BID ADDENDUM NO.1

2181539 Bank on Buffalo, Niagara Falls, NY

There was an error during the printing process that caused the structural & HVAC items to not appear in the Architectural drawings. Some of the drawings being replaced are only to show the missing items for clarification. No actual changes are occurring on these sheets. Any changes to the drawings are clouded & tagged.

1 REFLECTED CEILING PLAN - LIGHTING DIMENSIONS
A112 SCALE: 1/4" = 1'-0"

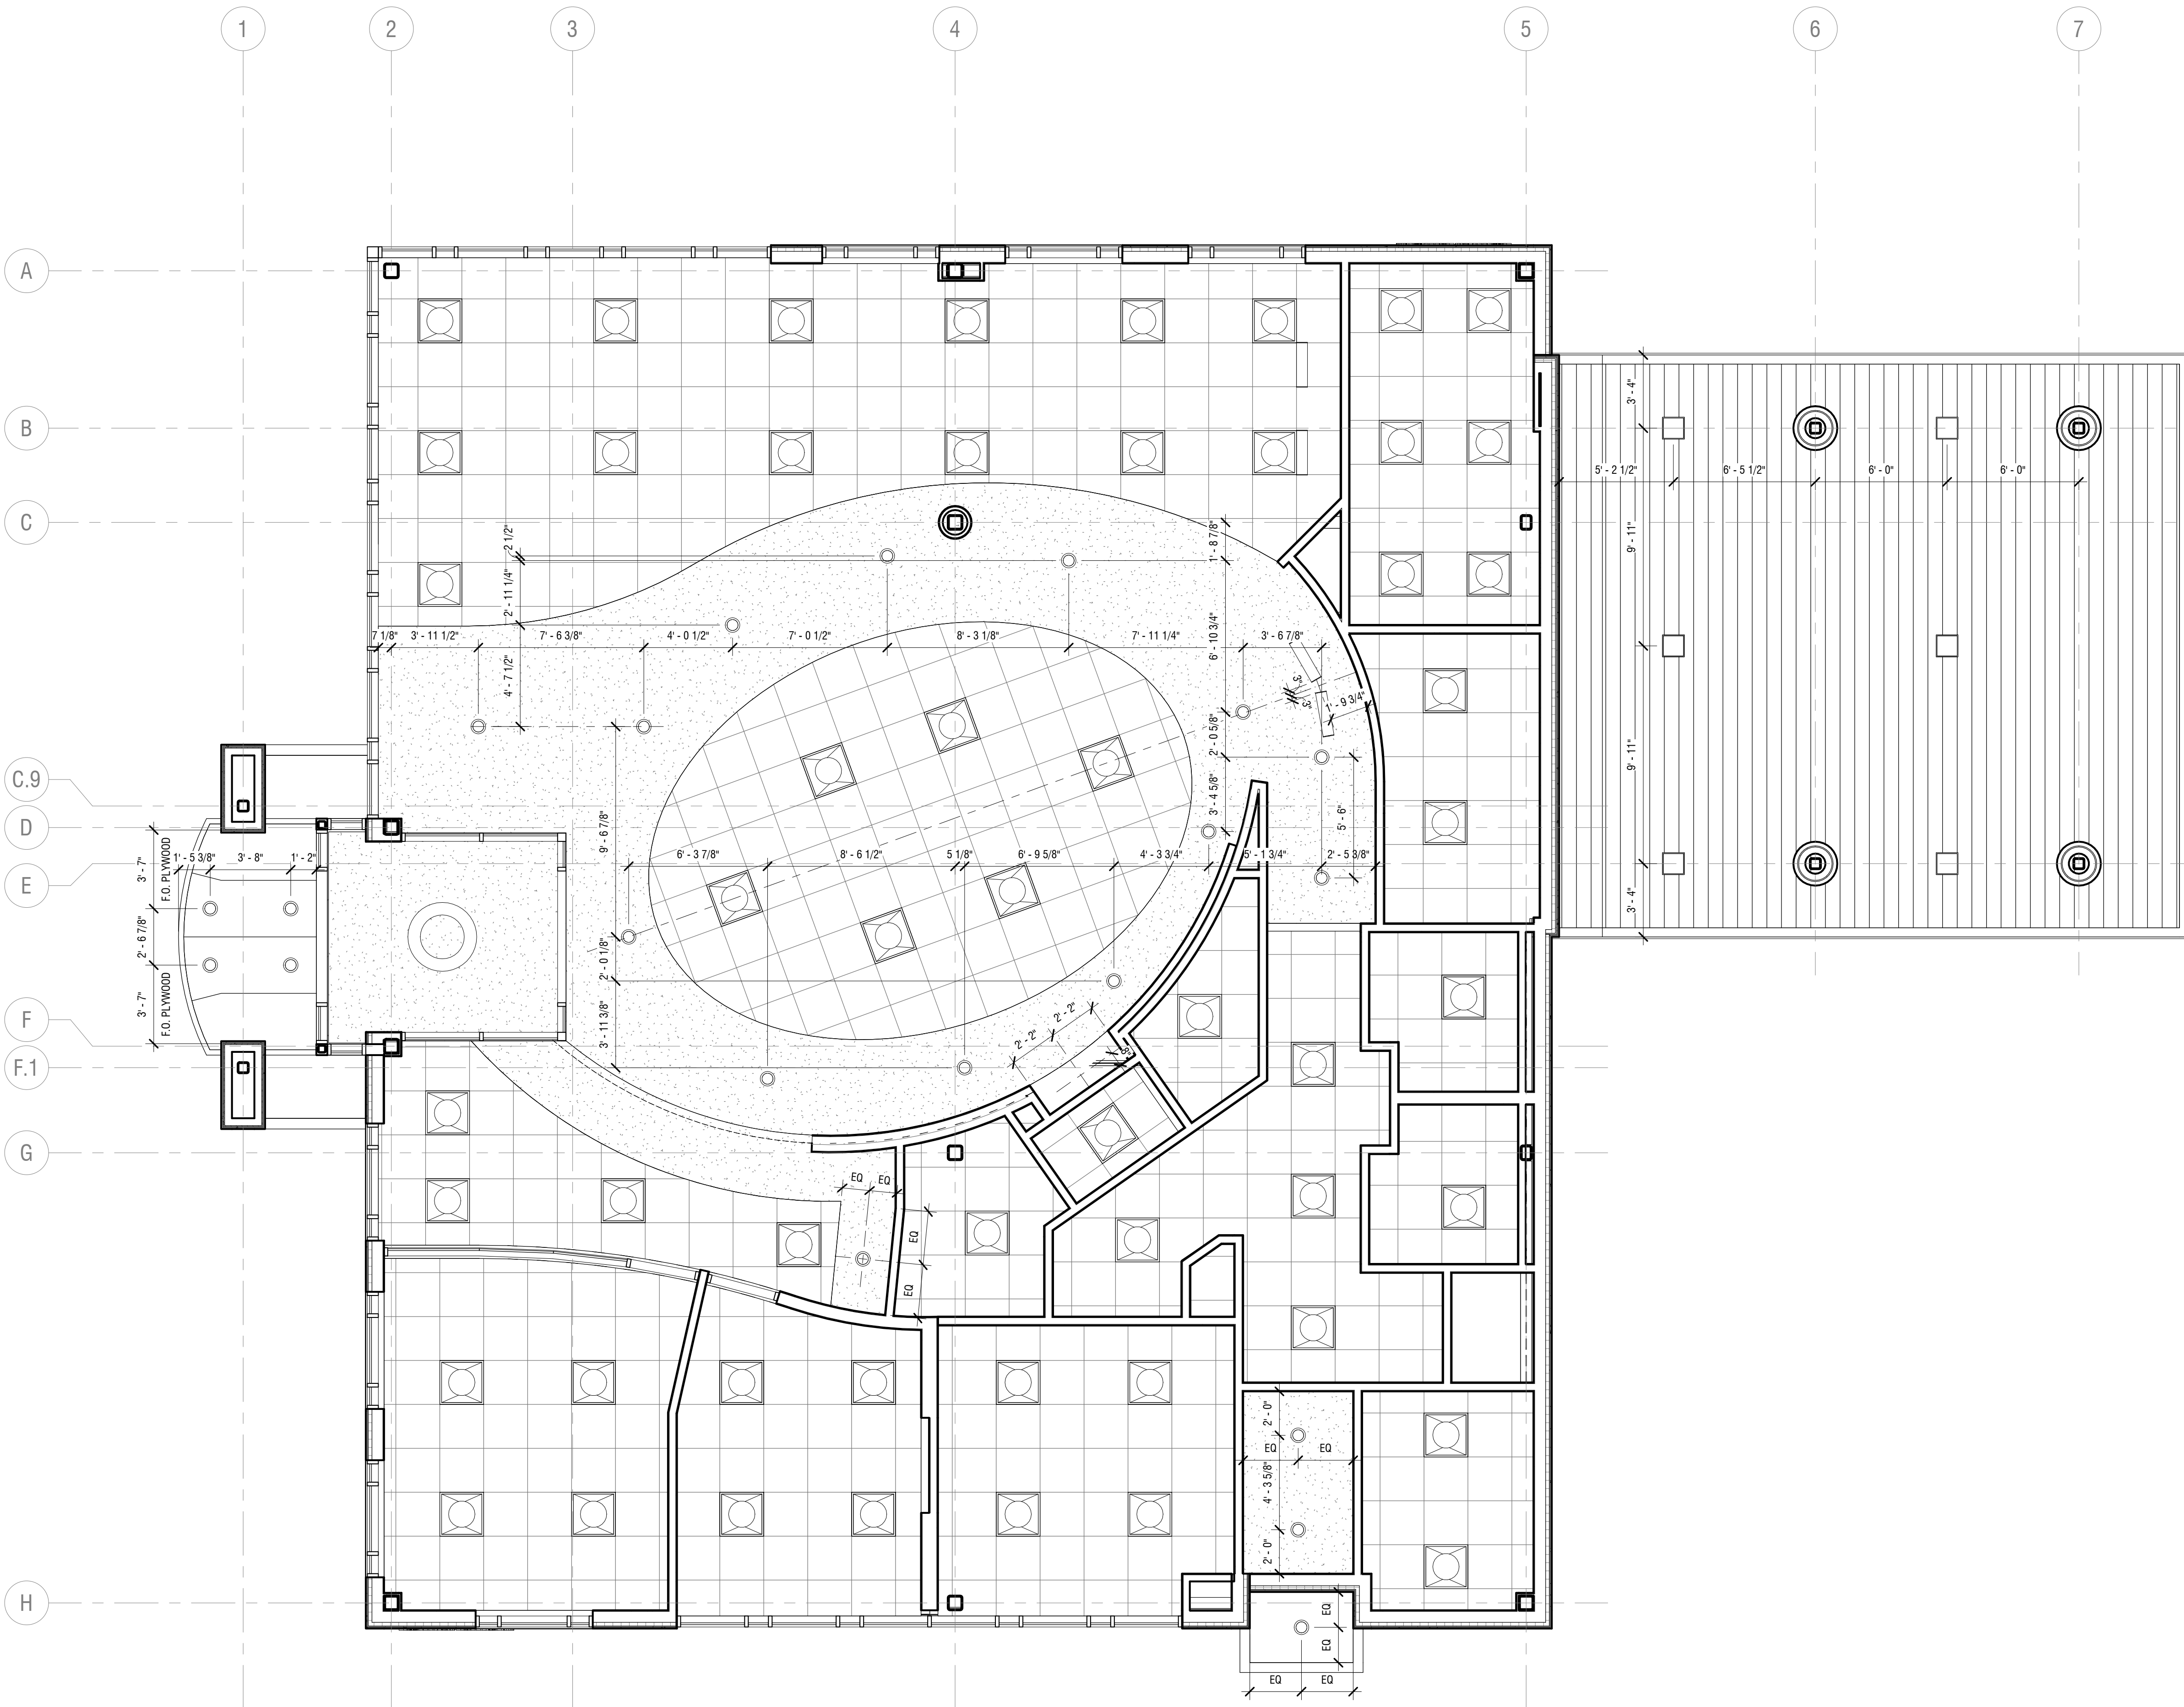
1. DELETE Drawing in its entirety
2. ADD replacement Drawing A112
3. HVAC shown on drawings.

1 NORTH ELEVATION
A201 SCALE: 1/4" = 1'-0"

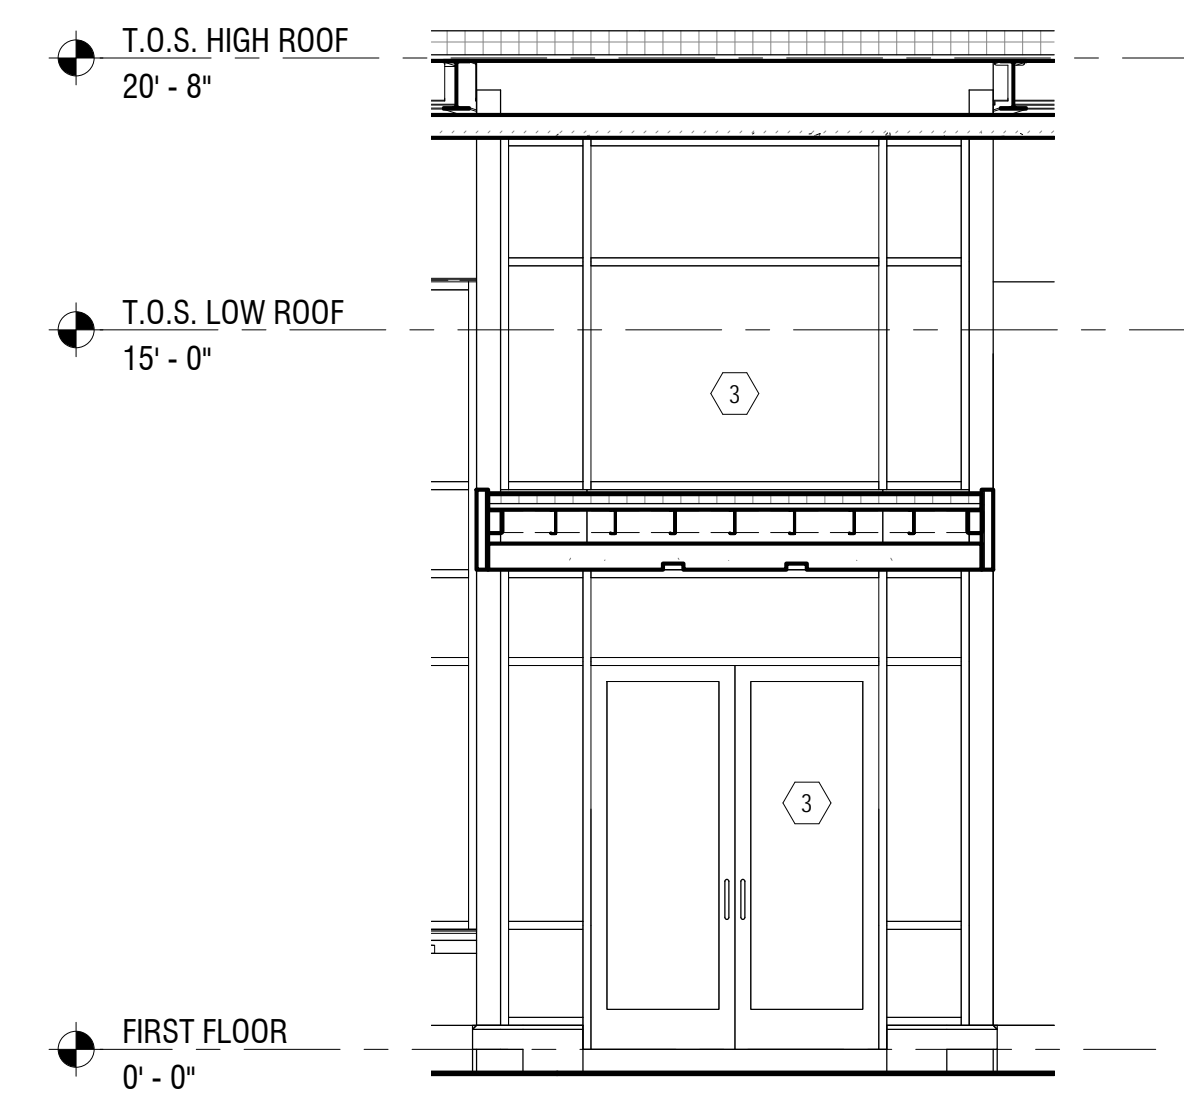
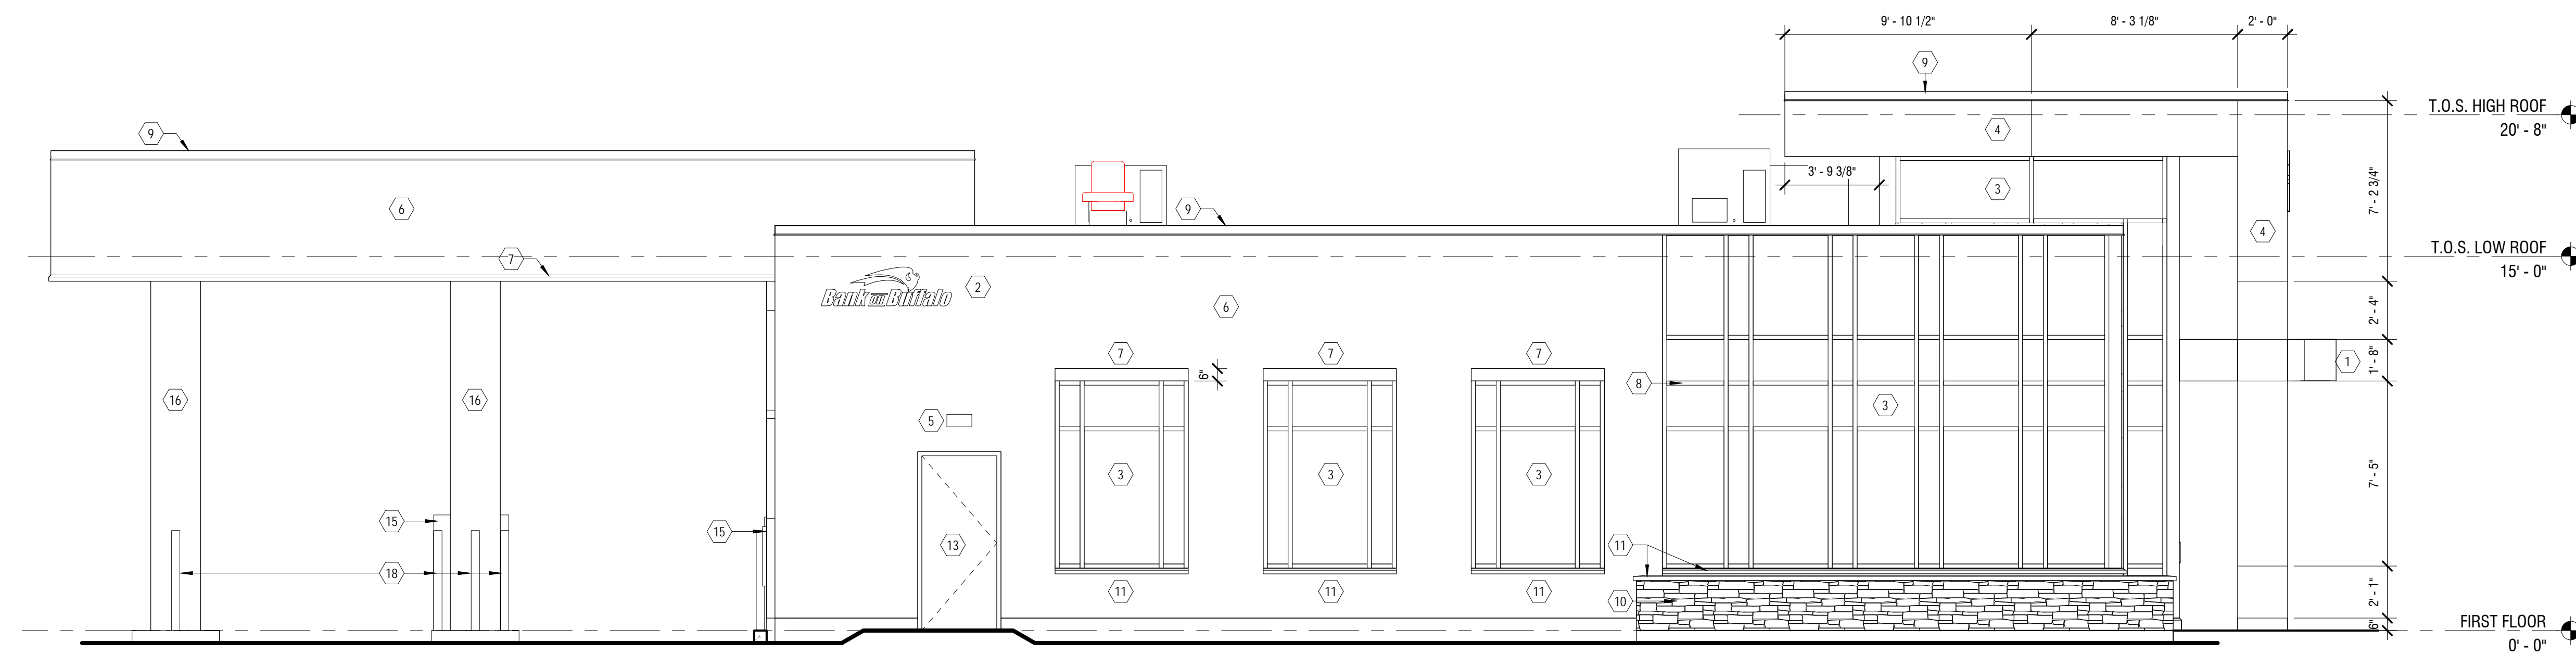
1. DELETE Drawing in its entirety
2. ADD replacement Drawing A201
3. HVAC shown on drawings.

1 SOUTH ELEVATION
A202 SCALE: 1/4" = 1'-0"

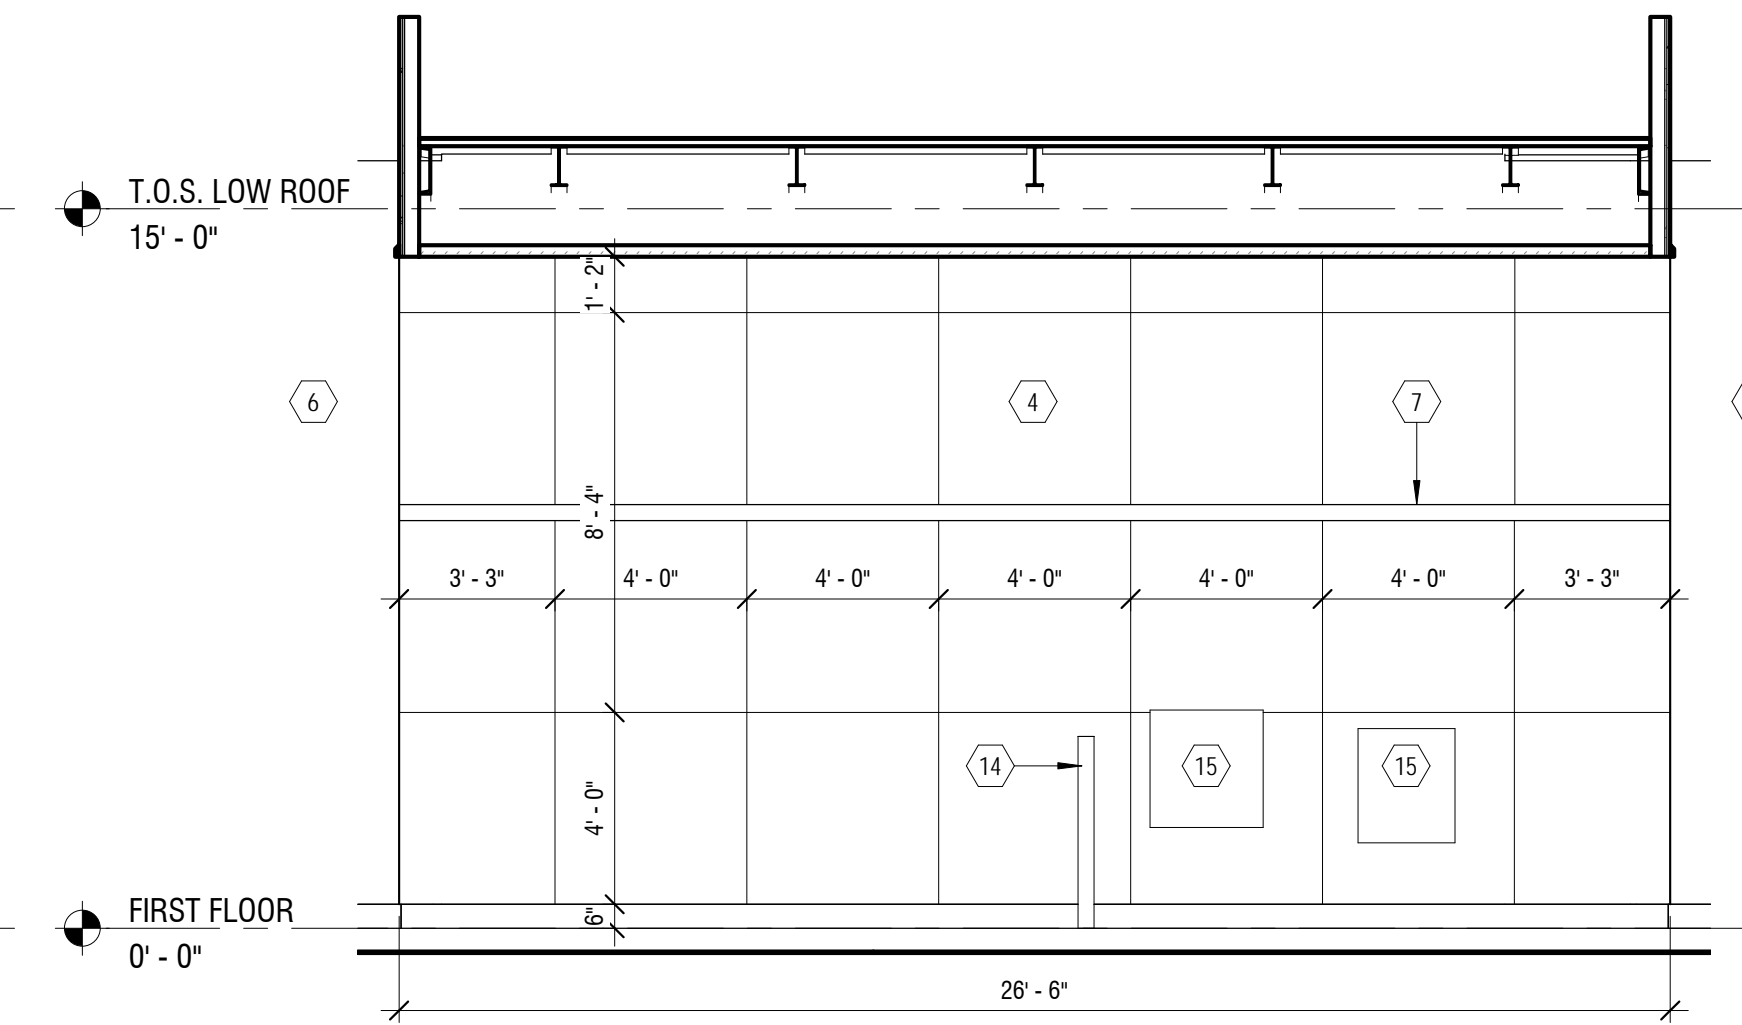
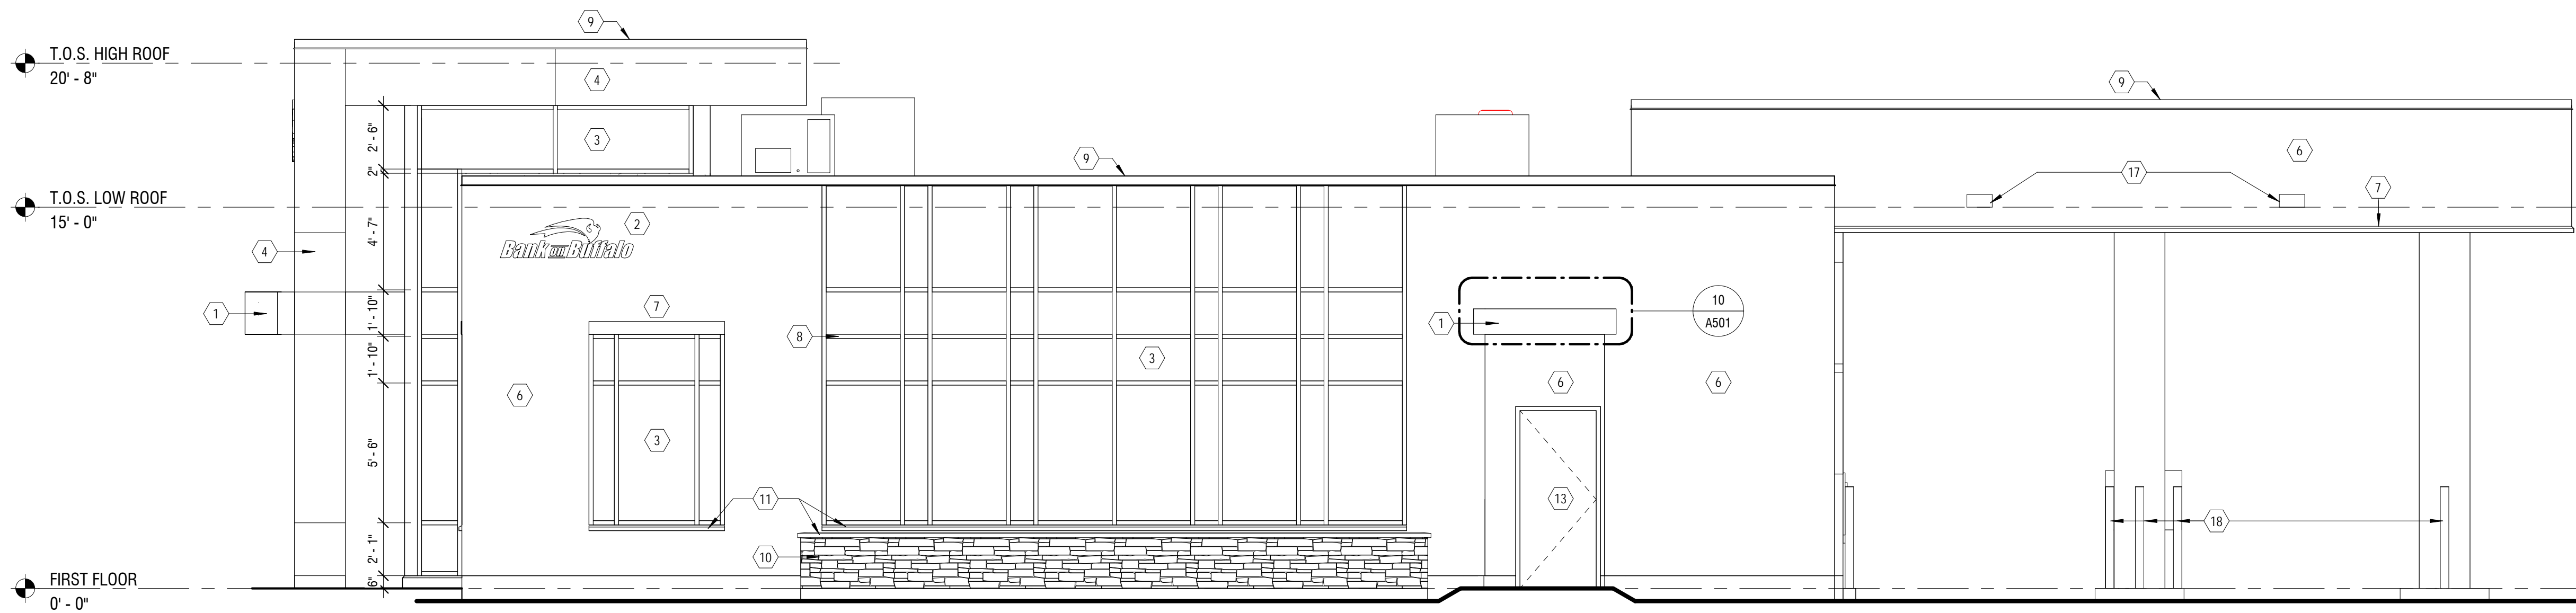
- F. Drawing A202**
 - 1. DELETE Drawing in its entirety
 - 2. ADD replacement Drawing A202
 - 3. HVAC shown on drawings.
